Access Compliance Report

Public Rights-of-Way

(Curb Ramps)

Intersection ID: 47454	Main Street: WOOD_DUCK_CROSSING_DR	Cross Street: WINGED_TEAL_RD	Location: SW
ADA ID: A8E1C6A036E9	Ramp Type: PerpDiag	Initial Pass/Fail: Pass	Overall Compliance: No
Severity Score: 0.25			
Codes/Mitigation Info/Possible Solution		Field Measurements/Component Compliance

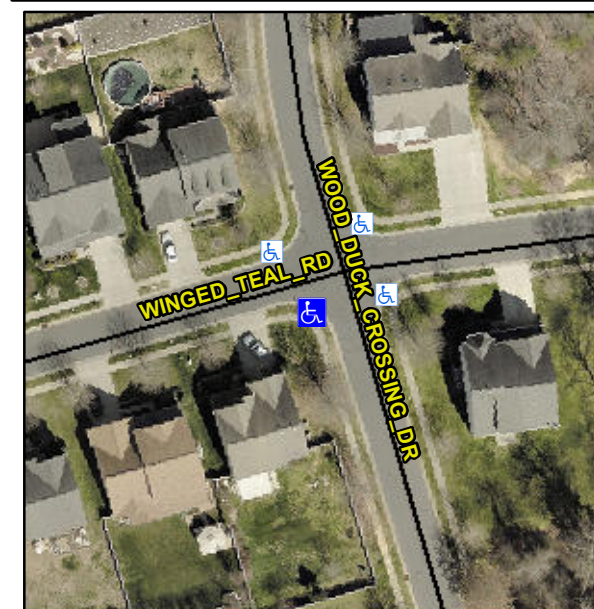
R304.5.3, R304.2.1, R305.2

Compliance	Description	Data	Compliance	Description	Data
N/A	Ramp Length (in)	46.0	Yes	Ramp Slope (%)	7.9
Yes	Ramp Width (in)	48.0	No	Ramp XSlope (%)	2.4
N/A	Flare Type LT	Sloped	N/A	Flare Type RT	N/A
N/A	Flare Slope LT (%)	1.9	Yes	Flare Slope RT (%)	7.0
N/A	Flare Traversable LT?	Yes	N/A	Flare Traversable RT?	Yes
No	Landing Length (in)	47.0	Yes	DWS Provided?	Yes
Yes	Landing Width (in)	48.0	Yes	DWS Contrast?	Yes
Yes	Landing Slope (%)	1.8	Yes	DWS Length (in)	24.0
No	Landing X Slope (%)	4.9	Yes	DWS Full Width?	Yes
N/A	Landing Curb? (Y/N)	No	No	DWS Offset (in)	2.3
N/A	Shared Landing?	No			
Yes	Gutter Ponding?	No	Yes	Gutter Slope (%)	1.3
Yes	Gutter Lip Ht (in)	0.0	No	Gutter X Slope (%)	2.7
N/A	Painted X Walk1?	No	N/A	Painted X Walk2?	No
	X Walk 1 Direction	To E		X Walk 2 Direction	To N
N/A	X Walk 1 Width (in)	N/A	N/A	X Walk 2 Width (in)	N/A
	X Walk 1 Slope (%)	0.5		X Walk 2 Slope (%)	4.8
	X Walk 1 X Slope (%)	3.3		X Walk 2 X Slope (%)	0.0

N/A	Ramp inside XWalk1?	N/A	N/A	Ramp inside XWalk2?	N/A
	Road Slope (%)	1.2	N/A	Clear Space?	Yes
	Road X Slope (%)	3.9	N/A	Clear Space to XWalk (in)	N/A
Yes	Any Obstructions?	No	Yes	Storm Grate/Utility Hazard?	No
	Obstruction Type			Storm Grate/Utility Type	
		N/A			N/A
		Yes		Surface Condition? (G/P)	Good

Remove & Replace Curb Ramp With Two New Directional Ramps or Equivalent. Remove & Replace Gutter.
